Re: Application of Row 44, Inc. for Special Temporary Authority
FCC File No. SES-STA-20080711-00928; Call Sign E080100

PETITION TO DENY OF VIASAT, INC.

REPLY OF VIASAT, INC.

Two-Way Fuselage Mount Antenna Transmit Gain

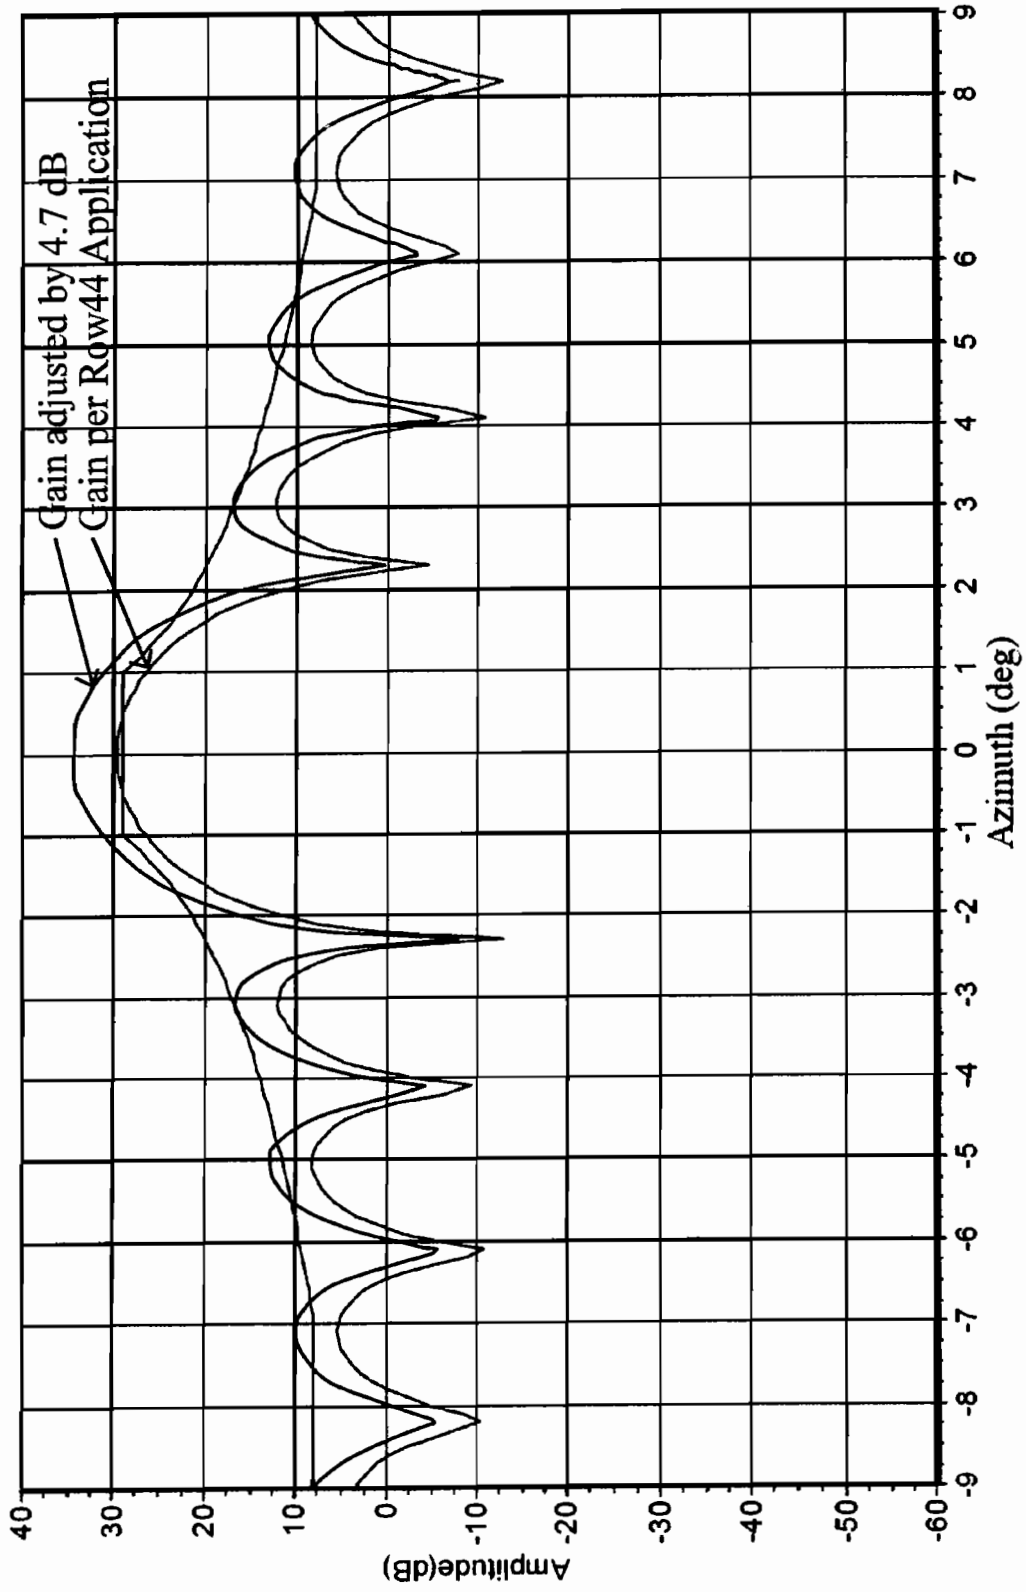
The 4.7 dB adjustment value is the difference between the 33.3 dBi gain specified in marketing materials released by the manufacturer (Aerosat) and the 28.6 dBi gain provided by Row 44 in the Application.

14.3 GHz Elevation Vertical Polarization

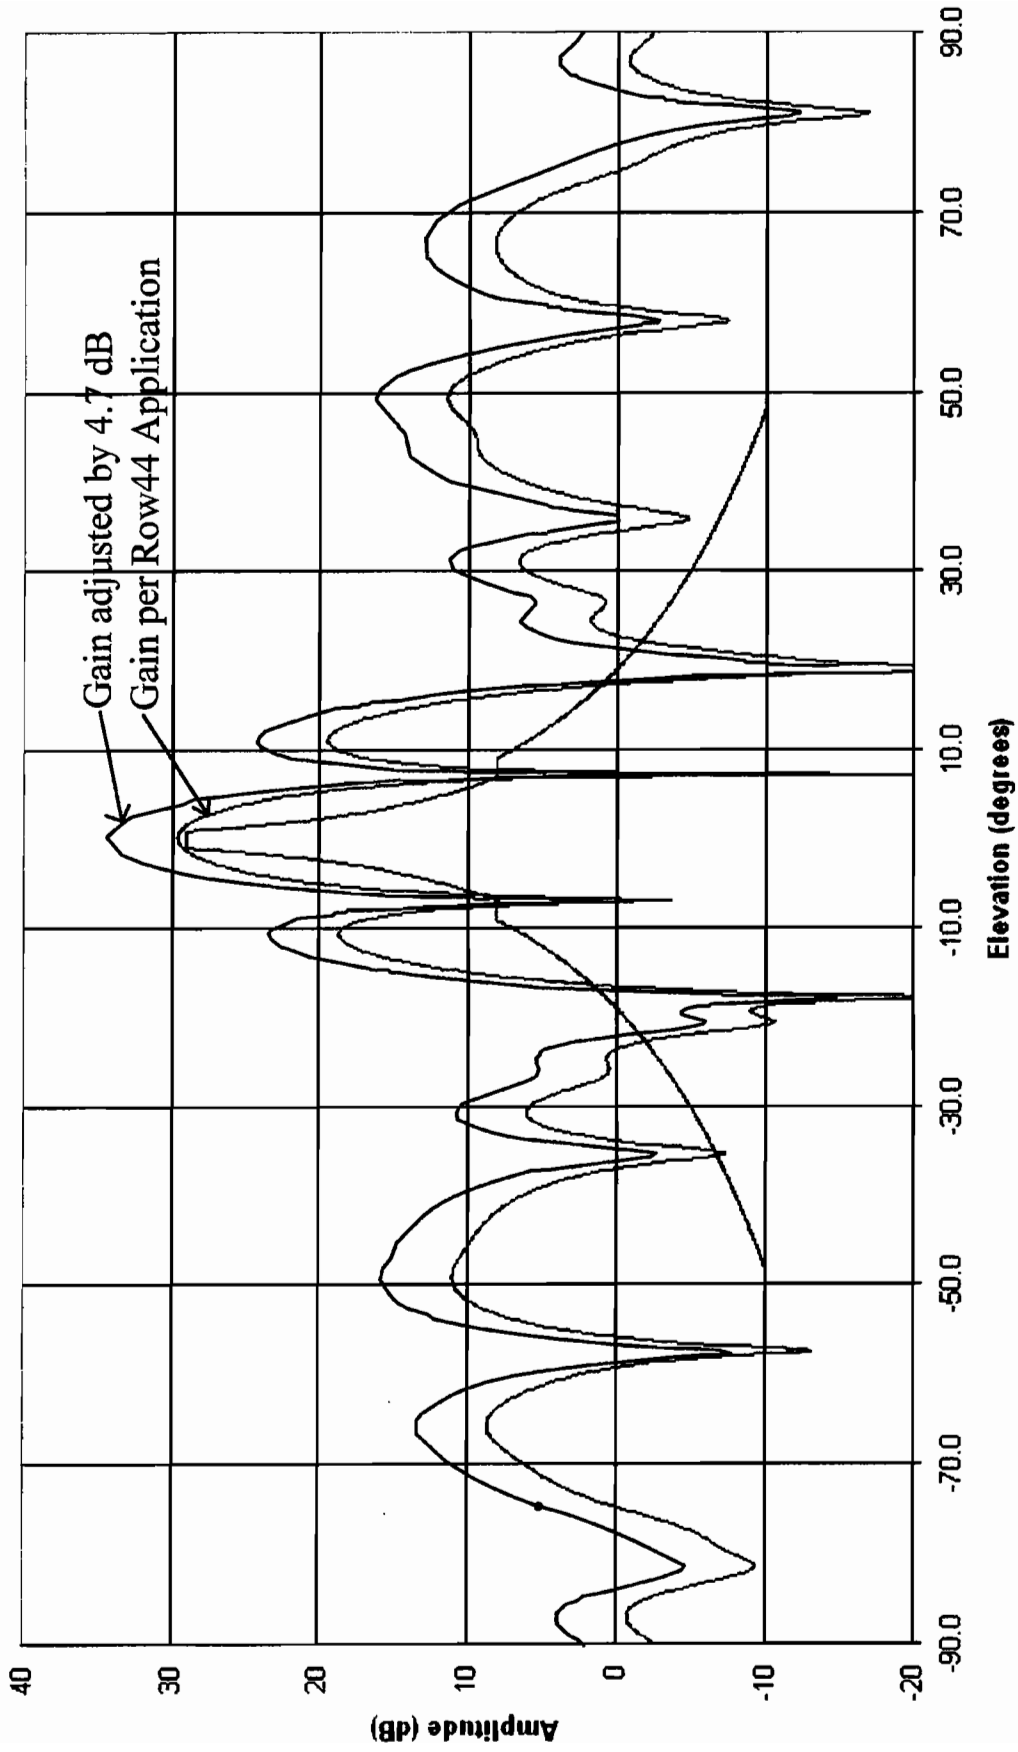
The 4.7 dB adjustment value is the difference between the 33.3 dB gain specified in marketing materials released by the manufacturer (Aerosat) and the 28.6 dB gain provided by Row 44 in the Application.
